UNITED STATES PATENT AND TRADEMARK OFFICE

Office Action Summary

Title: Router Bit System

Serial No.: 10/626,842

FIG. 1

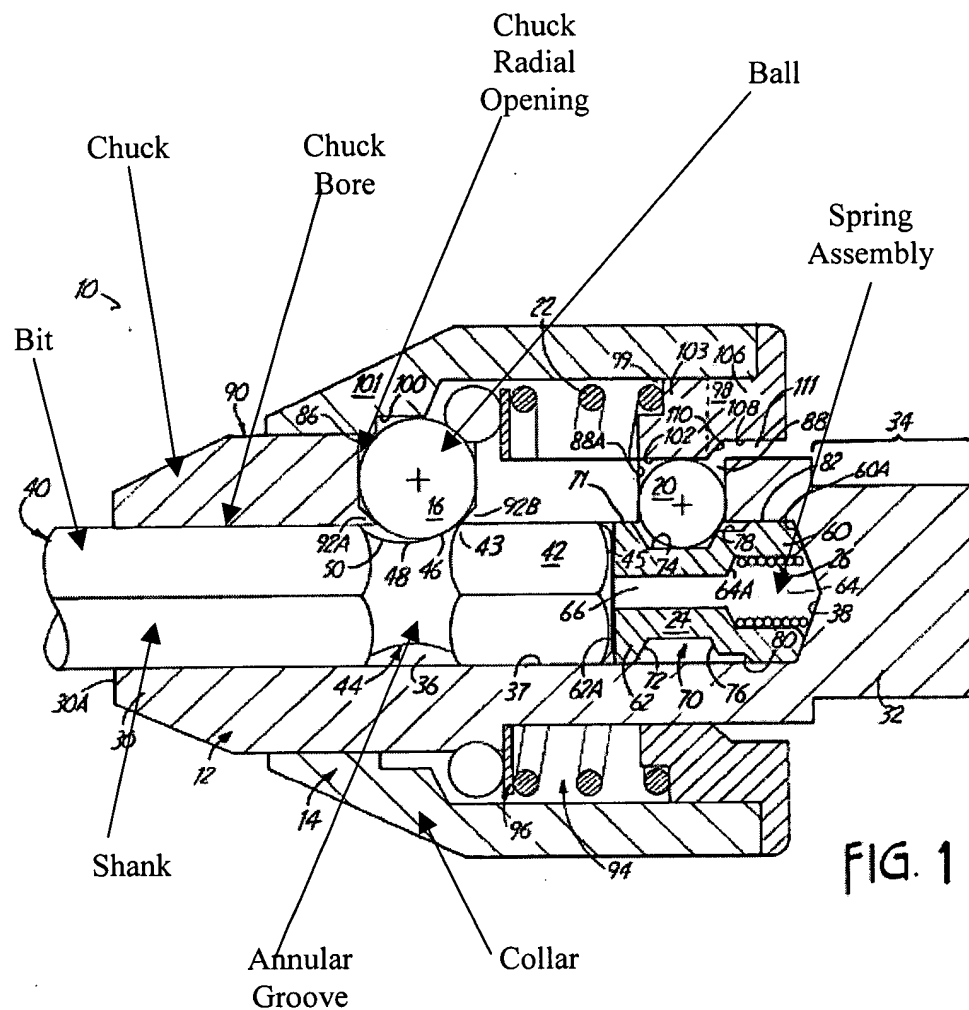
Regarding claims 1, 9 and 56, '841 teaches a rotary tool bit system including a cutter head and shank (see paragraph 0003); a router bit holding assembly including a chuck 12 having a bore (see figure 1 below) for receiving the shank (see figure 1 below), the chuck having an opening radially formed therein (see figure 1 below); a ball 16 received in the opening (see figure 1 below) for engaging the annular opening (see figure 1 below) of the shank (see figure 1 below) when the shank (see figure 1 below) is received in the bore (see figure 1 below); a collar 14 concentrically disposed about the chuck 12, the collar 14 sliding axially between a first position (see figure 1) and second position (see figure 2); wherein when the collar is moved to the first position (figure 1) the collar 14 is configured to hold the ball 16 in engagement with the annular groove (see figure 1 below) and when the collar is moved to the second position (see figure 2) the collar 14 is configured to allow the ball 16 to be disengaged from the annular groove (see figure 1 below).

Regarding claims 2 and 10 '841 teaches spring assembly for biasing the collar 14 to the first position (see figure 1 below and paragraph 0034, for example) and the compression spring being compressed as the collar 14 is moved to the second position.

Regarding claims 4, 5 and 12, as seen in figure 1 below, the tool bit has a tapered end and is the bore is configured to receive the shank.

Examiner notes that '841 does not expressly disclose the term "router" in the list of rotary tools.

FIG. 2

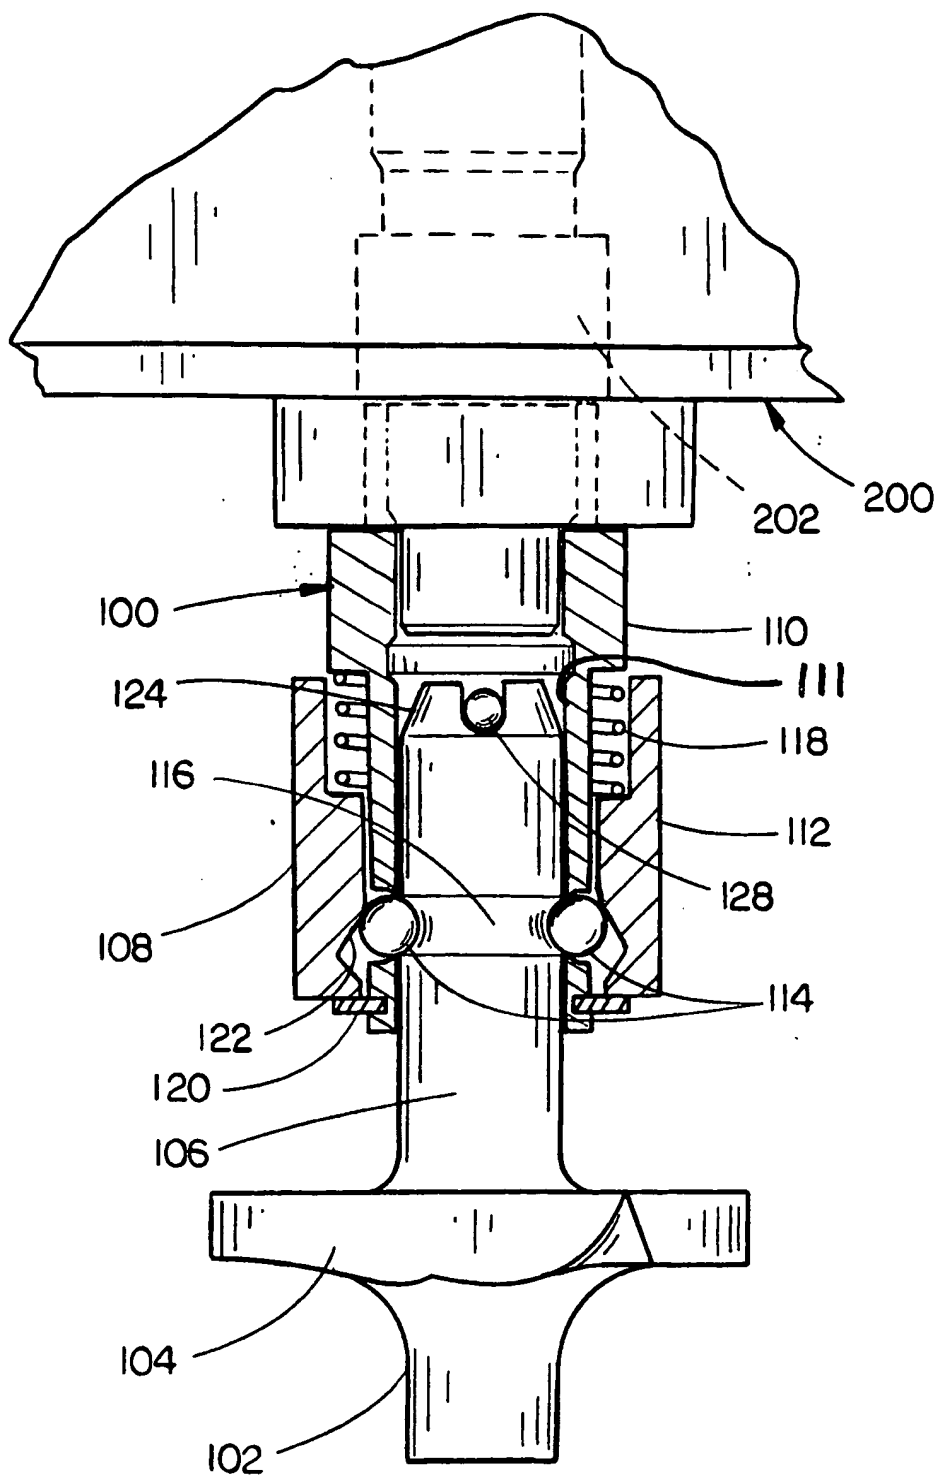
1. The replacement drawing sheet for Figure 2 was received on 13 February 2006. This drawing is acceptable.
